A585 Windy Harbour to Skippool Improvement Scheme

TR010035

7.11 Environmental Statement Changes and Corrections Document

Environmental Statement Changes and Corrections Document

FIGURE 9.10

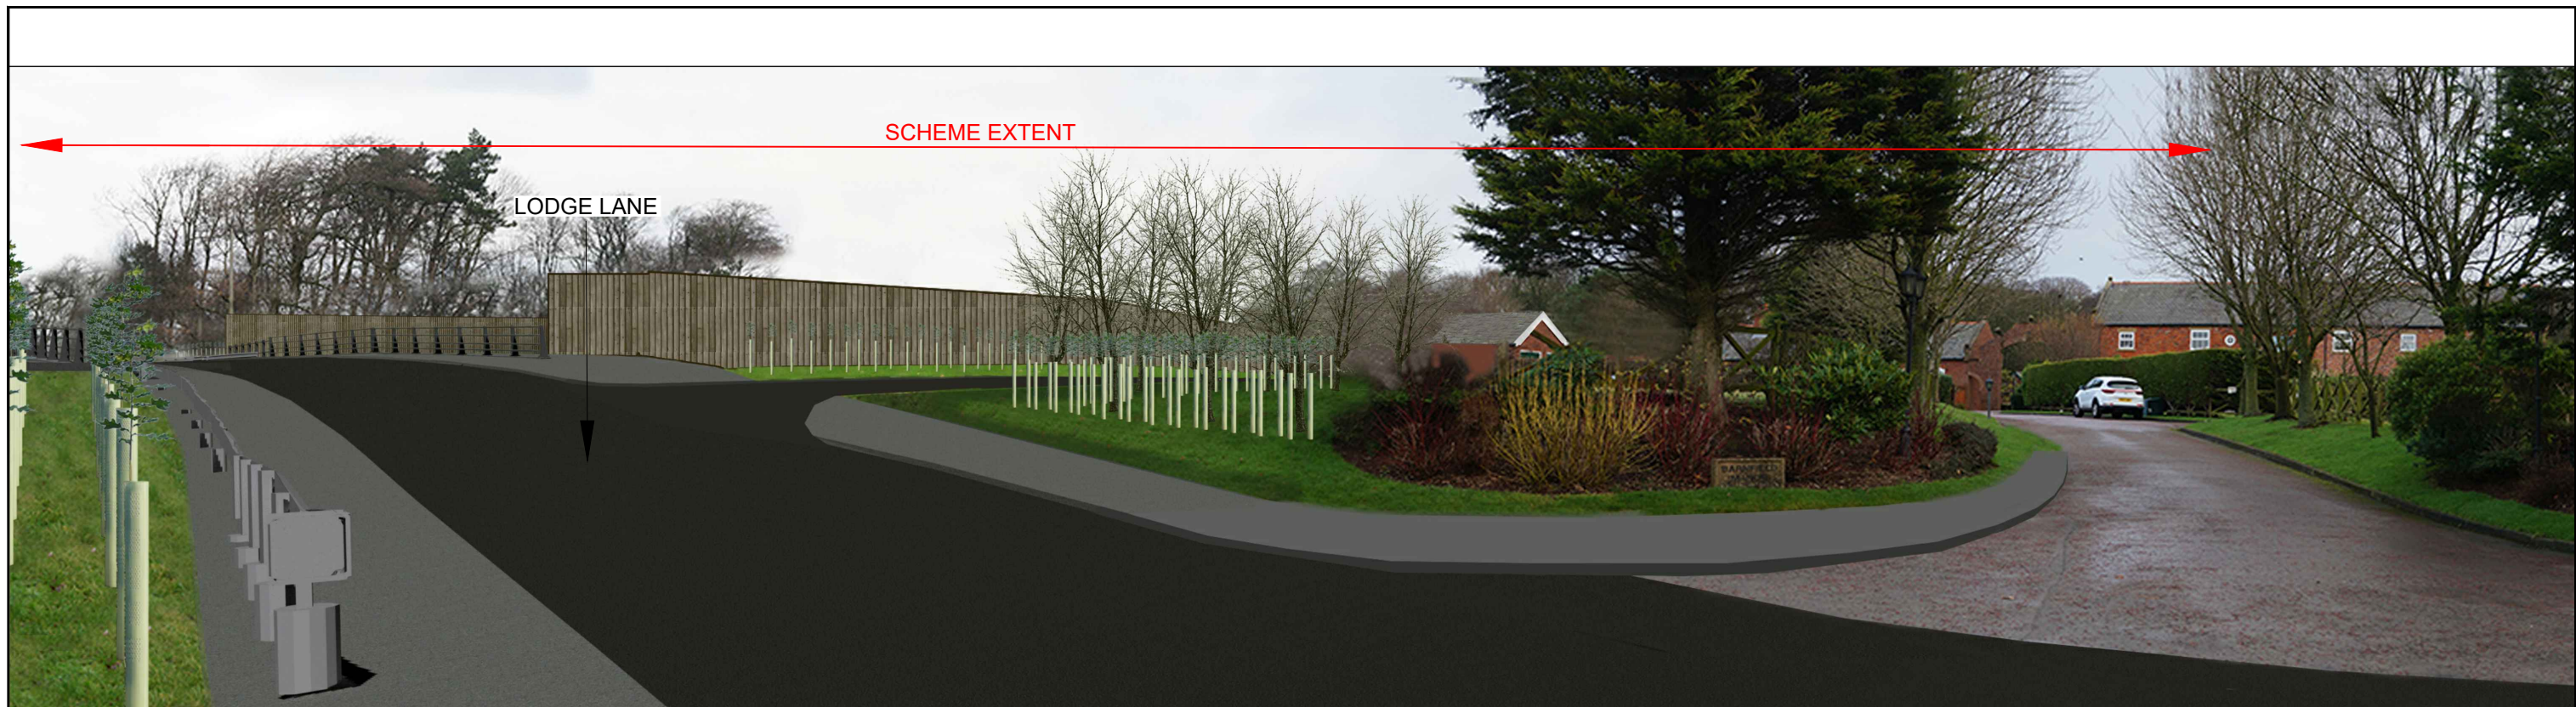
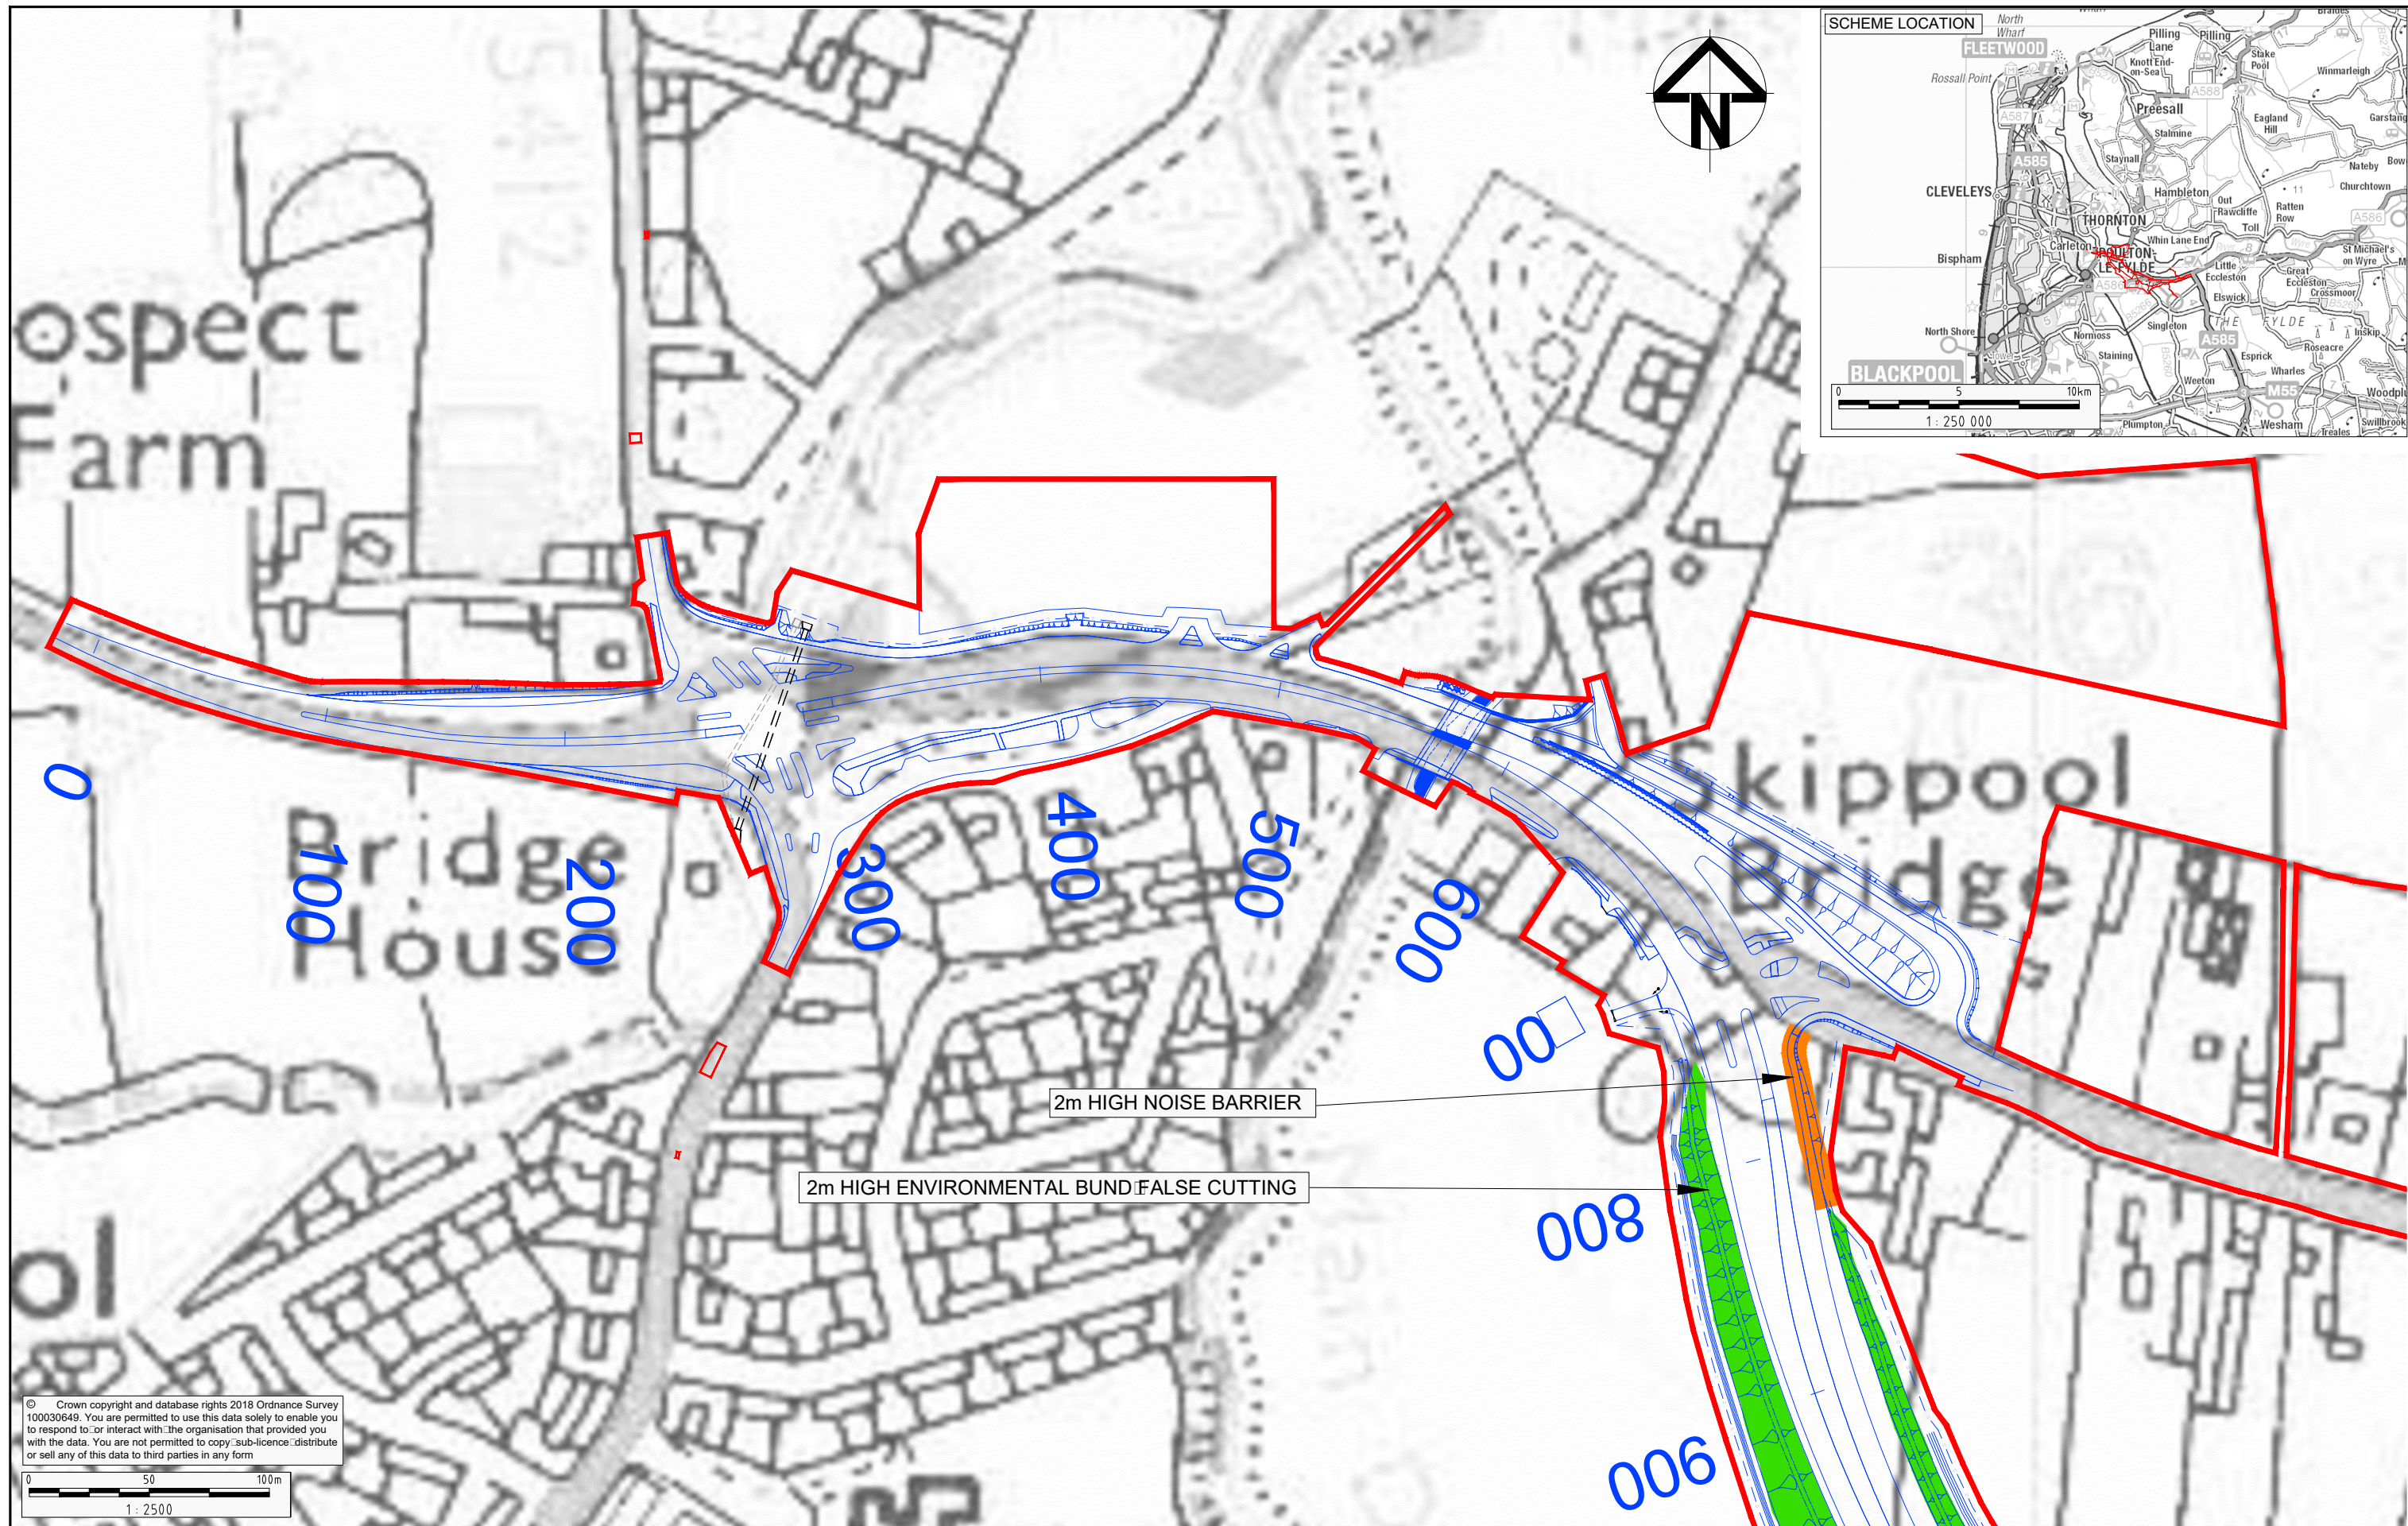
Document Reference Number	Document Name	Amendment Required	Reason									
6.9	ES Chapter 9: Landscape	Update to Figure 9.10, Photomontage at Viewpoint Location 1, view from Breck Road / Wyre Way at the A585 provided within Appendix C.	Updated to show the provision of a fence at 183 Breck Road.									
6.9	ES Chapter 9: Landscape	Update to Figure 9.10, Photomontage at viewpoint location 2 – Revision 2, view from residential properties on Breck Road provided within Appendix C.	As a result of updates to the Flood Risk Assessment associated with the dwarf wall and the provision of a fence at 183 Breck Road.									
6.9	ES Chapter 9: Landscape	Update to Figure 9.10, Photomontage at viewpoint location 10, view from the B5260 Lodge Lane provided within Appendix C.	Updated to show the 3m high acoustic barrier to the north of the cutting.									
6.9	ES Chapter 9: Landscape	Update to Figure 9.10, Photomontage at viewpoint location 9, view from the A585 Garstang New Road provided within Appendix C.	Updated to show the additional linear planting adjacent to Grange Footbridge, as a result of request from Fylde Borough Council (document reference TR010035/APP/7.9).									
6.9	ES Chapter 9: Landscape	Update to Table 9-16
